COMMENT SET 12

RE:DEIR 724, SCH#2001021119
PRC-421 Pier Removal Project

Overview of Venoco Ellwood Facilities

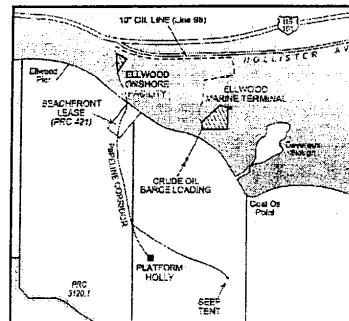
The blast effect of the external method could have consequences. The oil line that goes from Platform Holly to Venoco EMT goes trough the middle of PRC 421; the same goes for the seep tent line (see attachment). Comparing the maps, the one in the DEIR Appendix A,pg.3 is different from the one of the Energy Division briefing for the City of Goleta. Why is this?

- 12-4. The closest active pipeline(s) within State Lease PRC-421 pass through the southwest corner, approximately 1,650 feet from the project site. These pipeline(s) then pass to the northwest (in another lease) of the project site approximately 900 feet distant. The Proposed Project would use linear shaped charges which are highly specialized "cutting devices" that project the explosive reaction inward along a very narrow line. They are not "shattering devices." Extensive calculations were prepared by JRC Corporation and presented in the application to the State Lands Commission. These calculations indicate a very rapid dropoff in overpressure and therefore not affect thin-hulled project vessels at a distance of only 150 feet. Pressure pipelines that are capable of withstanding substantially more force than experienced by a sea-going vessel will not be affected.

The figure shown in Appendix A of the DEIR appears to show more pipelines than the figure attached to the comment letter. It may be possible that the County did not include the additional lines because they are not associated with Veneco Ellwood Facilities.
